Government of the District of Columbia

MEMORANDUM

SUBJECT: ZC Case No. 19-29 – 1348 4th Street NE

SUMMARY OF DDOT REVIEW

Figure 1 | Site Plan

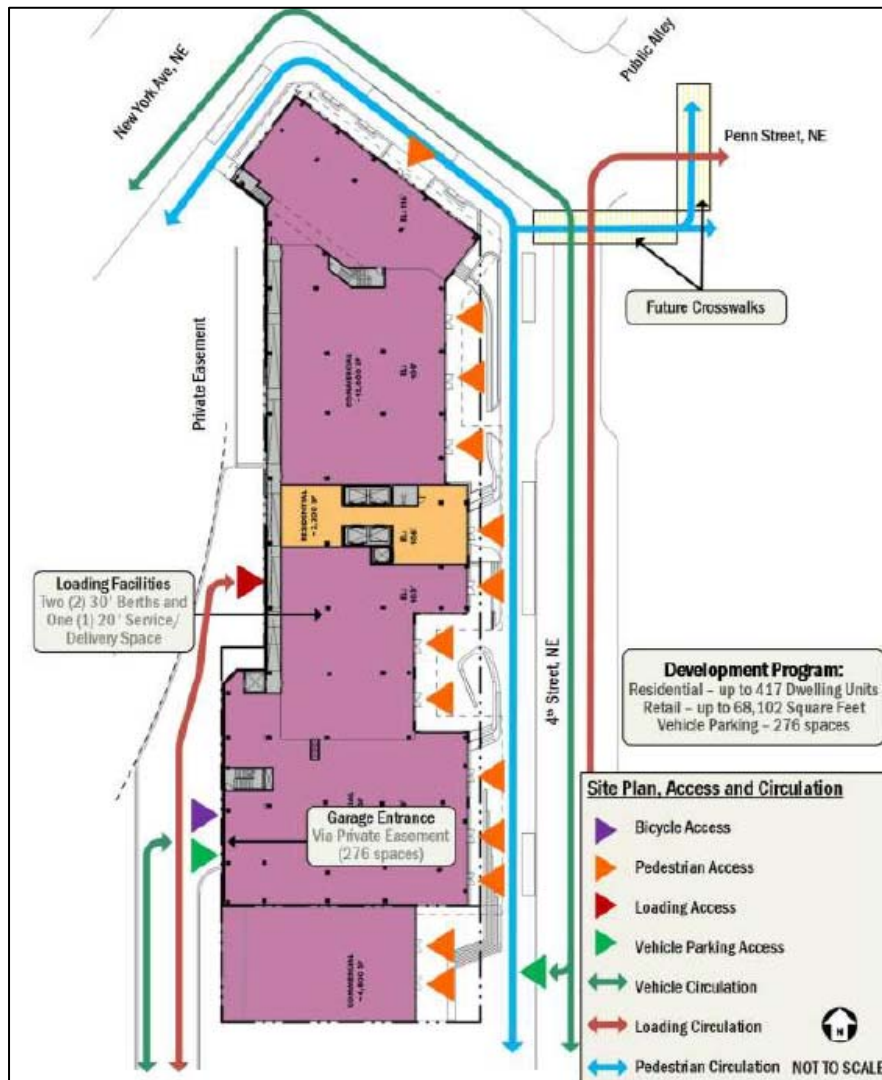
While the preliminary public space plans, shown above in Figure 1, are generally consistent with DDOT standards, there are several considerations that need to be reviewed in greater detail during the public space permitting process:

- All elements in public space should be consistent with the *Union Market Streetscape Design Guidelines*;
- The proposed parklets in the parking lane should be consistent with DDOT's *Parklet Guidelines* and the *Union Market Streetscape Design Guidelines* should not be amended;
- DDOT concurs that the existing curb cuts on 4th Street NE and New York Avenue should be closed and replaced with sidewalk, green space, and street trees;
- Explore opportunities to construct a pedestrian connection at the rear of the building to New York Avenue;
- Building projections on 4th Street NE should not project more than 4 feet into public space;
- Canopies should not project more than 5 feet into public space;
- Short-term bicycle spaces should be located within 120 feet of the main entrance to the building and otherwise meet the guidelines of the *Bike Parking Design Guide*;

- An occupancy permit will be required for any outdoor dining in public space on the sidewalk subject to approval by the Public Space Committee; and
- Submit a detailed curbside management and delivery plan for the curbside space adjacent to the subject site.

Figure 5 | Existing Bicycle Facilities

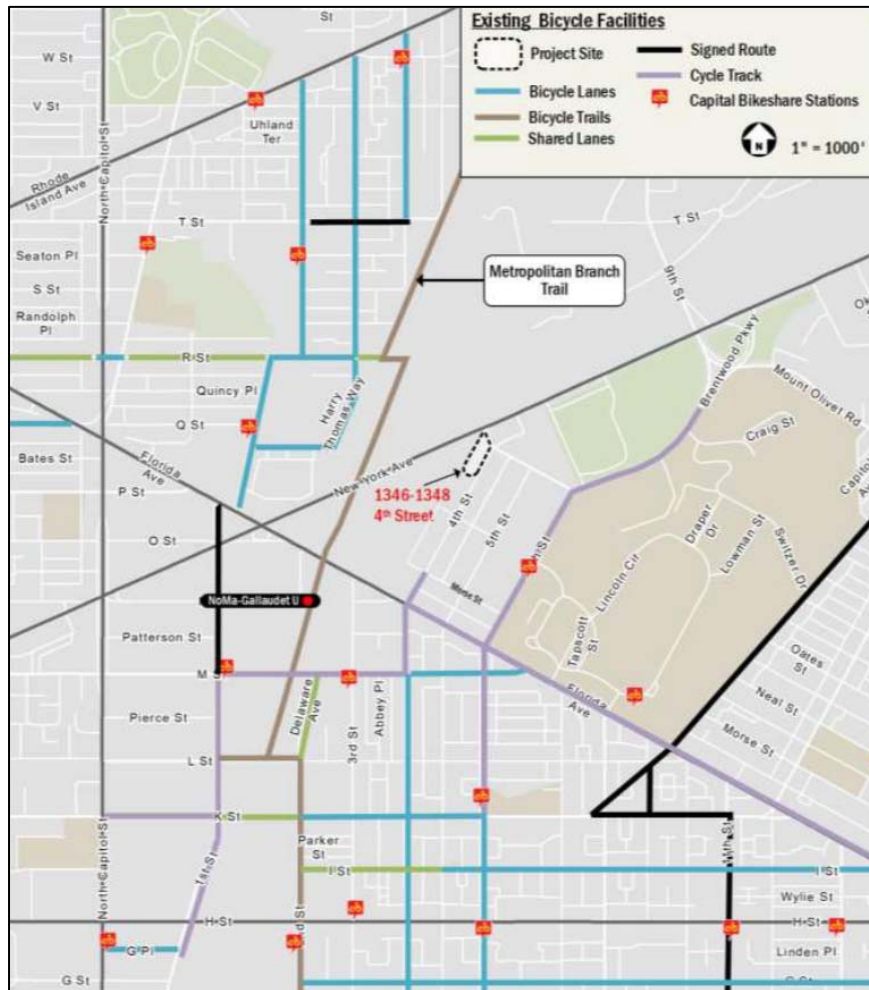
As shown below in Figure 5, there are several bicycle facilities within the vicinity of the site, including two (2) Capital Bikeshare stations within a half-mile of the site, cycle tracks on 6th Street NE and Florida Avenue, and the Metropolitan Branch Trail. However, the graphic is missing the existing and planned cycle track segments on the private alley connecting to the rear of the site.
